Staff Report

Re: PLNPCM2021-00168; PLNPCM2021-00167 – Neighborhood Industry Design Review & Planned Development

NEIGHBORHOOD INDUSTRY –DESIGN REVIEW & PLANNED DEVELOPMENT

Property Address: 439 West 600 South
Parcel IDs: 1512127001-006; 1501379003; 1501379007; 1501379009
Zoning District: CG (General Commercial)
Master Plan: Central Community

Figure 4: West Elevation Neighborhood Industry Parking Structure

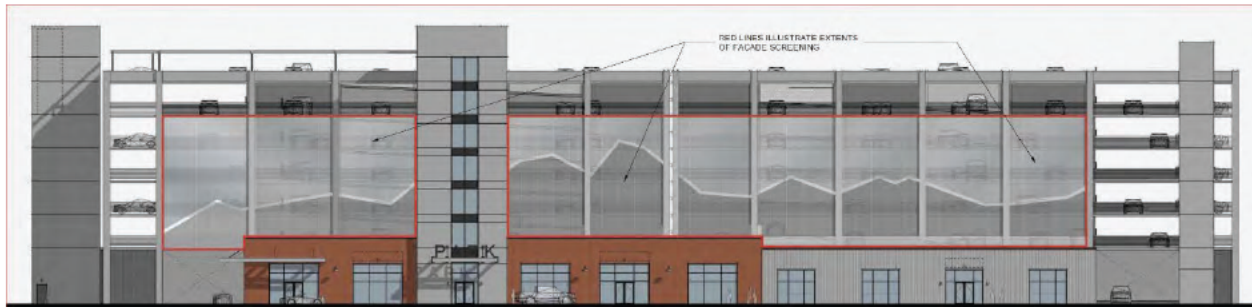
The CG district permits a building height of 60' by right. The district permits additional building height of 30' if the criteria for a Design Review is met, and if additional standards in the CG zone are met. These additional CG zone building height standards include:
